NP-11-0038
August 17, 2011

Subject: Exelon Nuclear Texas Holdings, LLC
Victoria County Station Early Site Permit Application
Response to Request for Additional Information Letter No. 08
NRC Docket No. 52-042

Attached are responses to NRC staff questions included in Request for Additional Information (RAI) Letter No. 08, dated April 19, 2011, related to Early Site Permit Application (ESPA), Part 2, Sections 02.03.02, 02.04.03, 02.04.12, and 02.04.13. NRC RAI Letter No. 08 contained fourteen (14) Questions. This submittal comprises the final partial response to RAI Letter No. 08, and includes responses to the following two (2) Questions:

Figure 1: Location of Cells With the Potential for Flooding Under Pre-construction Conditions

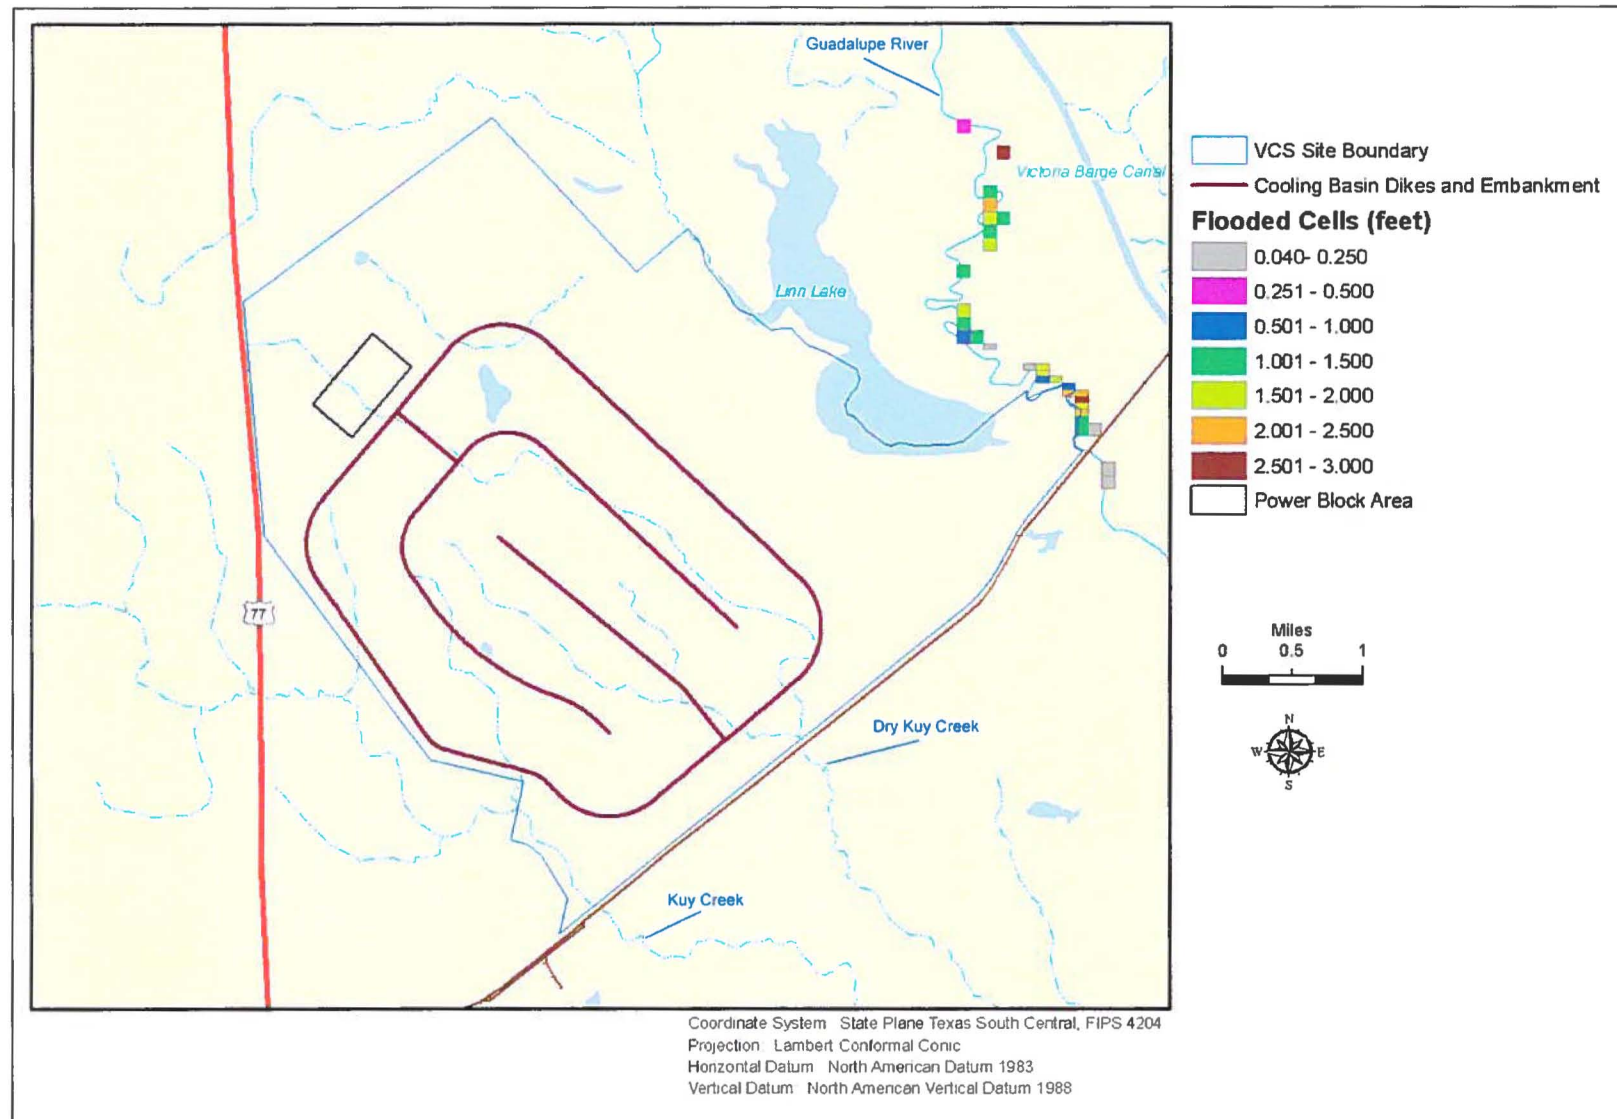
In accordance with the requirements of 10 CFR 100.20(c) "Factors to be considered when evaluating sites" relating to hydrology and, 10 CFR 52.79(a) "Contents of applications; technical information in final safety analysis report" relating to hydrologic characteristics of the proposed site, and as recommended by Standard Review Plan 2.4.12 "Groundwater" acceptance criteria, additional information concerning the groundwater flow modeling is required for the NRC Staff's evaluation of the Application.

The response to RAI 02.04.12-2E includes the technical basis and background to describe those areas, particularly around the proposed cooling basin, where predicted groundwater potentiometric levels are above land surface for pre-construction and post-construction conditions and the resulting impacts to model calibration and simulations. Of particular concern are areas around the toe of the cooling basin embankment where steep gradients in the potentiometric head are created by seepage and subsequent drainage by Dry Kuy Creek.

To determine the areas of the VCS site where the predicted groundwater potentiometric levels are above the land surface, the model land surface elevations (the elevation of the top of model layer 1) were subtracted from the simulated elevations of the groundwater potentiometric heads in model layer 1. Figure 1 shows the pre-construction conditions, where the model land surface elevations were subtracted from the simulated pre-construction elevations of the groundwater potentiometric heads in model layer 1. Model cells with groundwater potentiometric head elevations above the land surface elevation are denoted as "flooded" cells. No "flooded" cells are observed near the proposed cooling basin in the pre-construction model simulation. However, as would be expected, "flooded" cells are located at the Guadalupe River in areas where the hydraulic head in the river is higher than the land surface elevation. Because no "flooded" cells occur under pre-construction conditions throughout most of the model domain, and flooding of no more than three feet occurs in cells in the Guadalupe River, there is little potential for significant impact to model calibration.
